ZONING DIVISION STAFF REPORT

Project Address: 515 Pinney Street
Project Name: 515 @ Royster
Application Type: Approval for Comprehensive Design Review of Signage
Legistar File ID # [67175](#)
Prepared By: Chrissy Thiele, Zoning Inspector
Reviewed By: Matt Tucker, Zoning Administrator

2 FIRST FLOOR - OVERALL PLAN
A-0.1 1/16" = 1'-0"

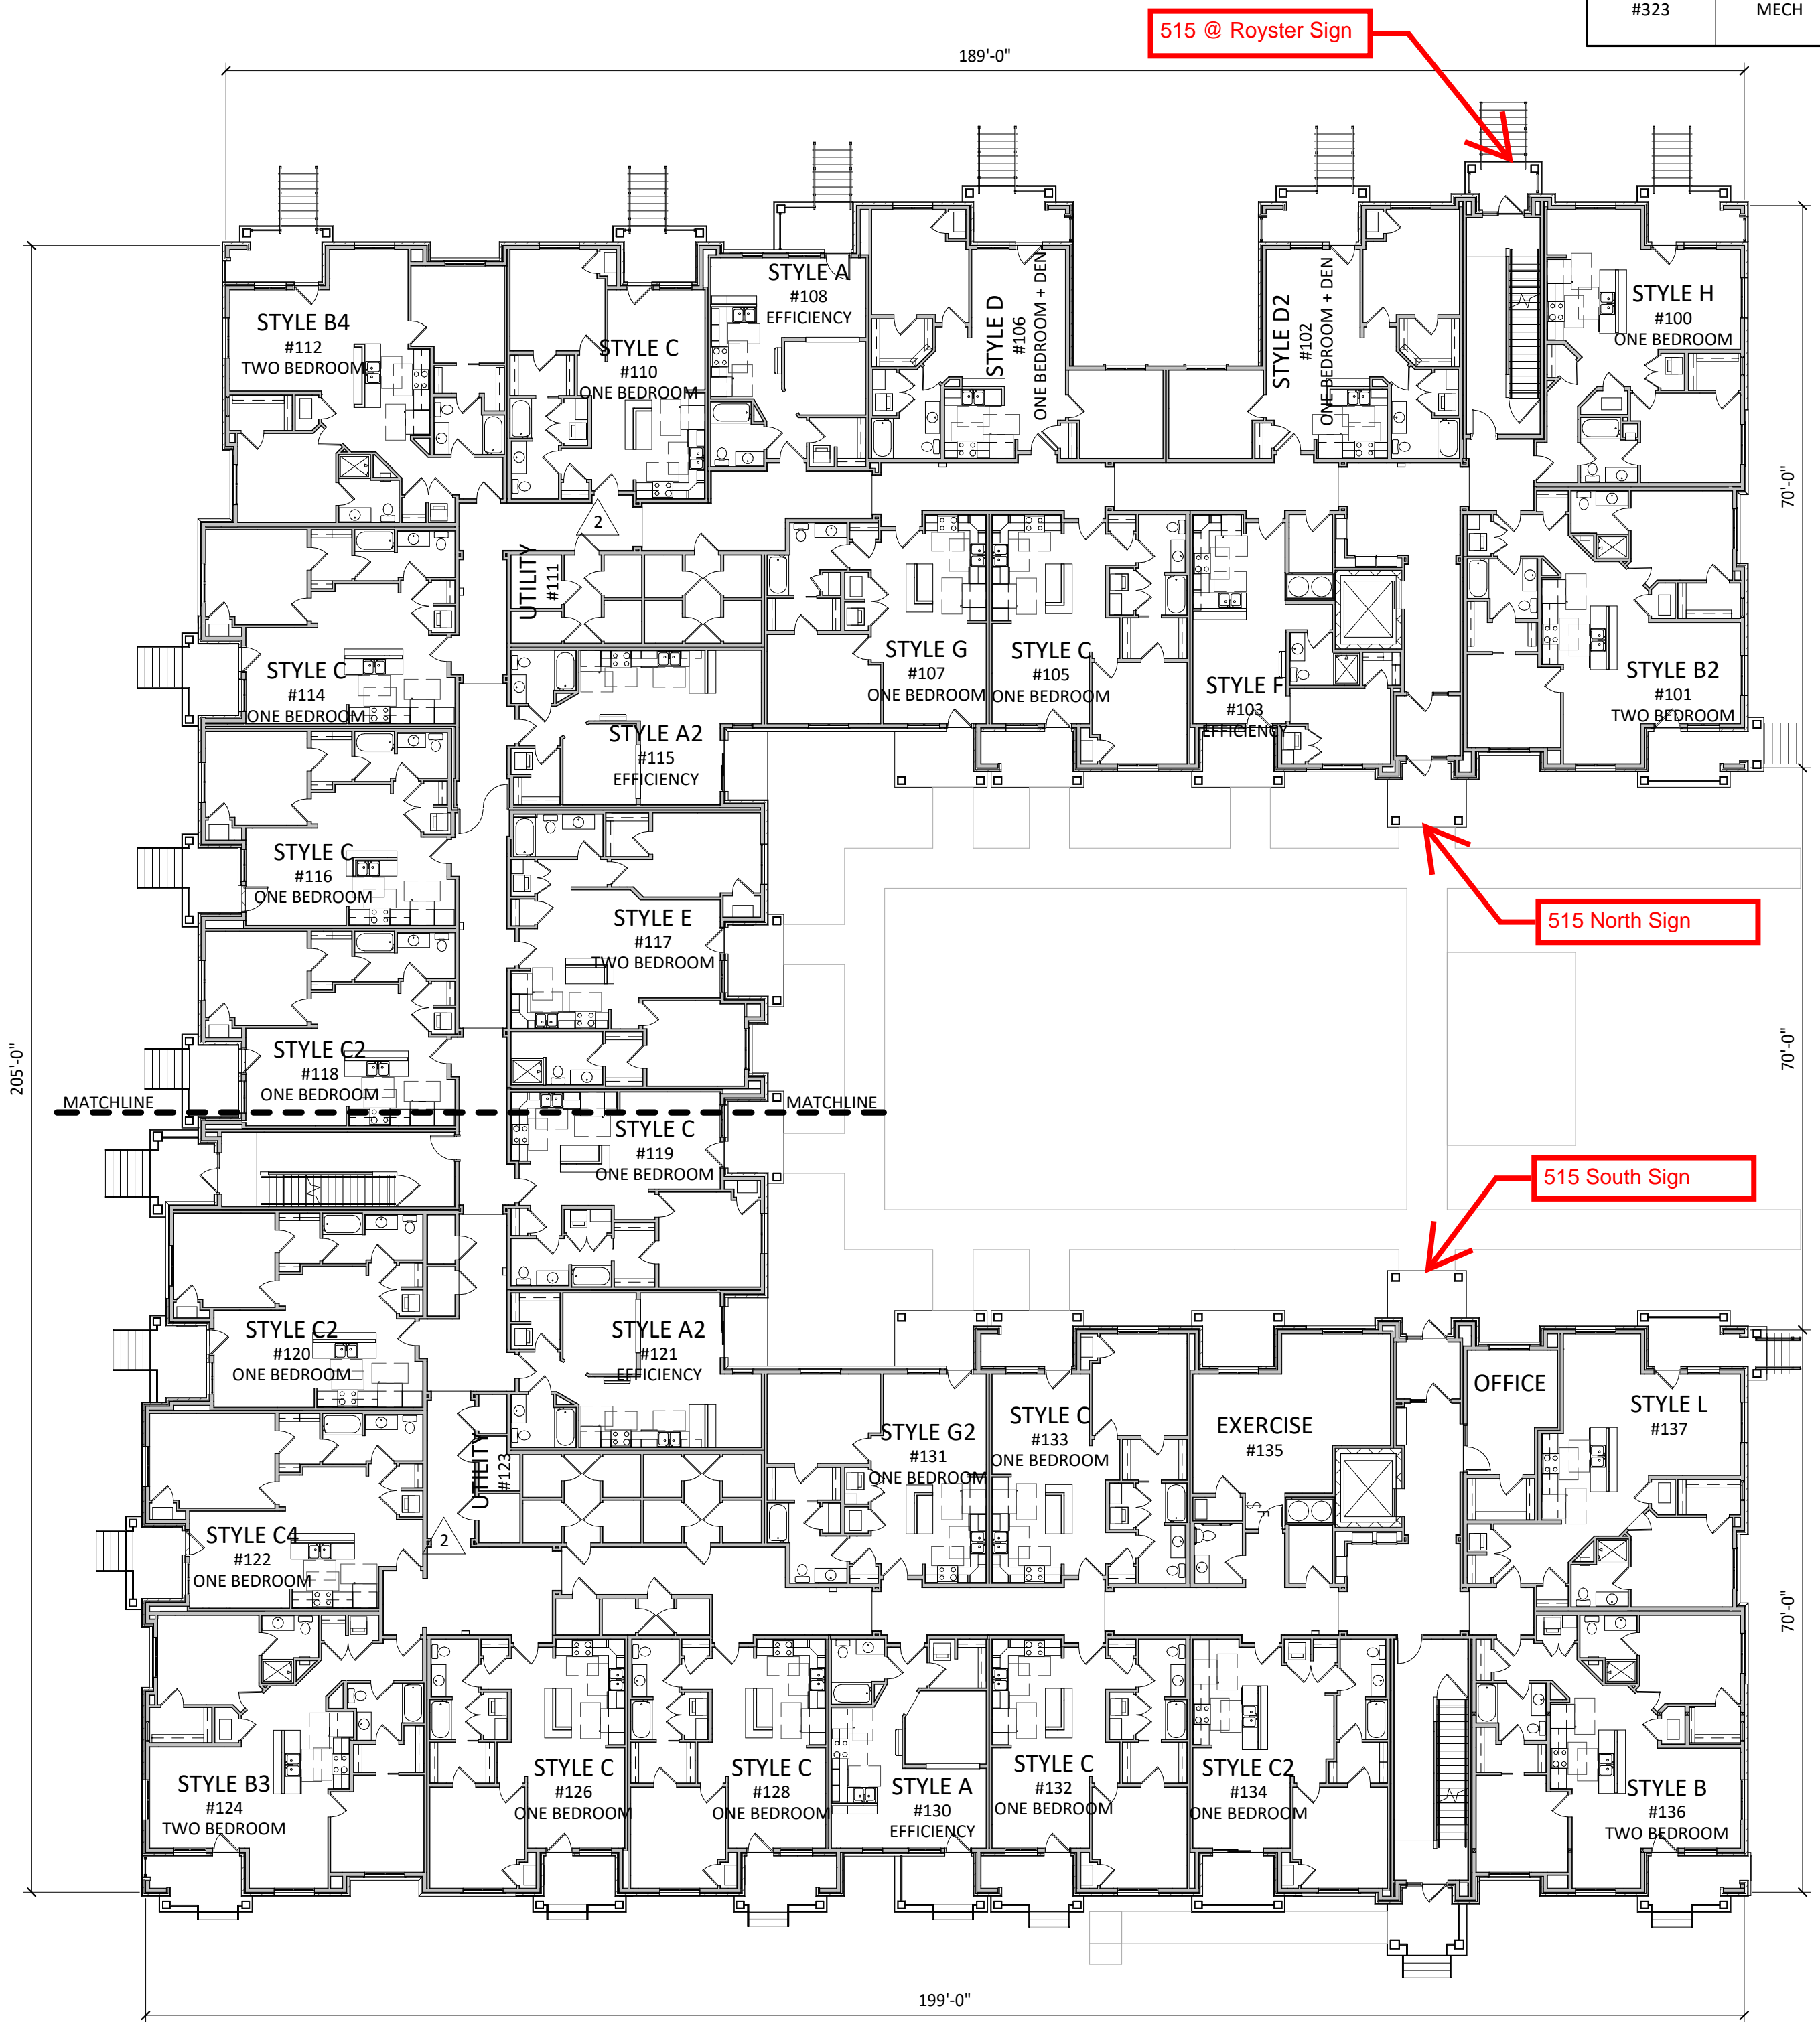
The apartment building was designed to have two primary entrances (see attached floor plan). One is located on the north interior courtyard and the other is on the south interior courtyard. The applicant is requesting for both of these entrances to have the above canopy signs, which will note the designated north and south entrances, in order to guide tenants and visitors to the appropriate entrance, as well as assist with mail/package delivery, as each entrance has its own mailbox and intercom system. The third above canopy sign is located above a private entrance/exit door that leads to a stairwell for the apartment building. It does not appear that visitors will be able to enter the building from this point. The applicant states the sign is needed so visitors can identify the building is 515 Pinney Street and not 515 Grand Oak Trail. Between the two style options provided (one being non-illuminated and 2' tall and the other internally illuminated and 2' 9" tall), the applicant does not provide a preference of one over the other.

It is reasonable to desire signage over the primary entrance to a building, especially when the primary entrance are not located where visitors would expect them to be, or where there are multiple primary entrances. However, Staff has concerns about the internally illuminated signs, since the signage will face the interior courtyard for the apartment, and how it could affect the residential units with windows facing the courtyard at night. Staff has reviewed the site plans submitted for zoning approval, and it is shown that lighting will be provided in the interior courtyard. Therefore, staff feels that the non-illuminated option to be sufficient, illumination not necessary. As for the above canopy sign that will face Pinney Street, which is located above a secondary entrance/exit door, Staff does not believe an adequate case has been made to allow this sign via CDR. 515 Grand Oak Trail is not an existing address, nor does the sign "515 @ Royster" seems confusing, and does not appear to identify that the building's address is 515 Pinney Street. The applicant also indicates that most traffic is expected to come from the parking lot entrance off of Dempsey Road or Royster Oaks Drive. Therefore, having signage facing Pinney Street will not really assist with wayfinding or be visible to visitors coming to the building. Staff also has concern about an internally illumined sign facing a low density residential district across the street from Pinney. **Recommendation: Staff has no objection to the CDR request for the two non-illuminated above canopy signs located above the primary entrances, and recommends the UDC find the standards for CDR review have been met. However, staff recommends the UDC find the standards for CDR review have not been met for the request for the above canopy sign facing Pinney Street. This recommendation is subject to further testimony and new information provided during the hearing.**

- The final CDR documents shall state that all other signage not requiring permits shall comply with MGO 31.
- Artwork for canopy signs shall be revised as to not project beyond the face of the canopy.
